## SERVICE INSTRUCTION

# Introduction of a radiator retrofit kit part no. 881535 for the new radiator part no. 997083 on ROTAX® Engine Type 912 i, 912 and 914 (Series)

ATA System: 75-00-00 Cooling system

Fig. 1  
Radiator retrofit kit

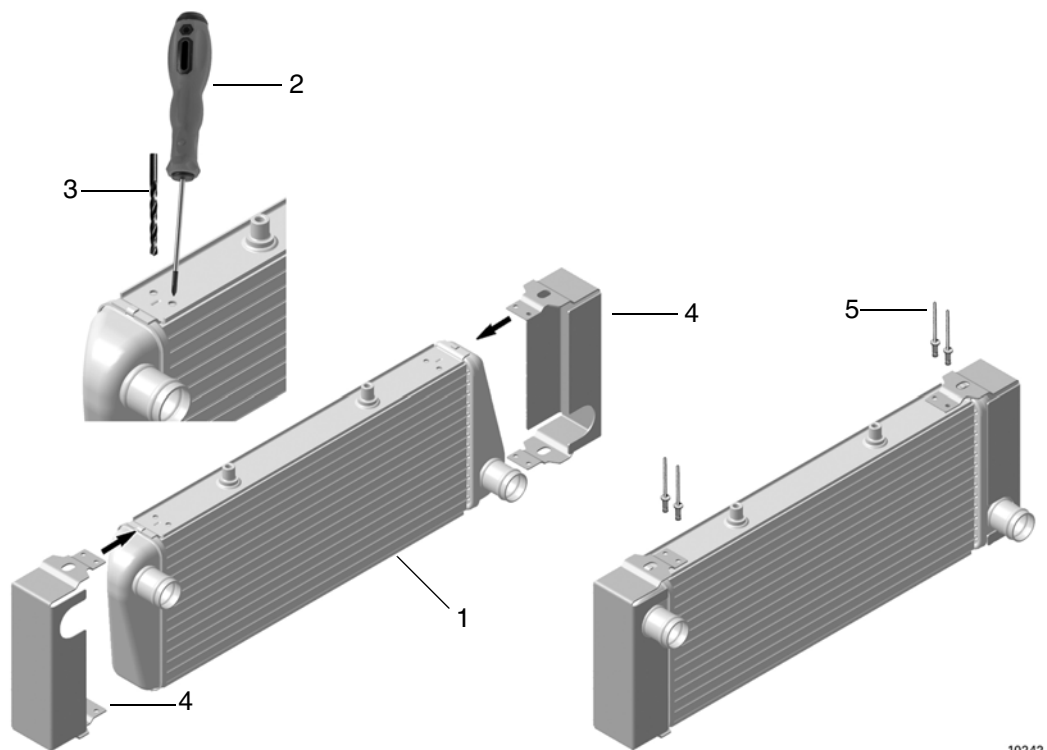
In the course of continuous development, a new radiator (part no. 997083) has been introduced. Because the radiator has a changed outside contour and dimension changes, a radiator retrofit kit, (part no. 881535) has been created, which should be used in installation situations where a rectangular mounting is needed. For this purpose, corresponding cover plates have to be riveted onto the radiator.

| Step | Procedure  |
|------|--|
| 1    | Enlarge the holes of the radiator (1), using a suitable screw driver (2). Tilt the fins slightly to the side.                                      |
| 2    | If necessary use a metal drill $\varnothing 4.1$ mm (3) to rebore the holes of the radiator and the cover plates (4).                              |
| 3    | Install the cover plates and observe the correct mounting position.  |
| 4    | During the riveting process apply some force to the rivets (5), so that they are pushed into the holes. Reposition the riveting tongs accordingly. |
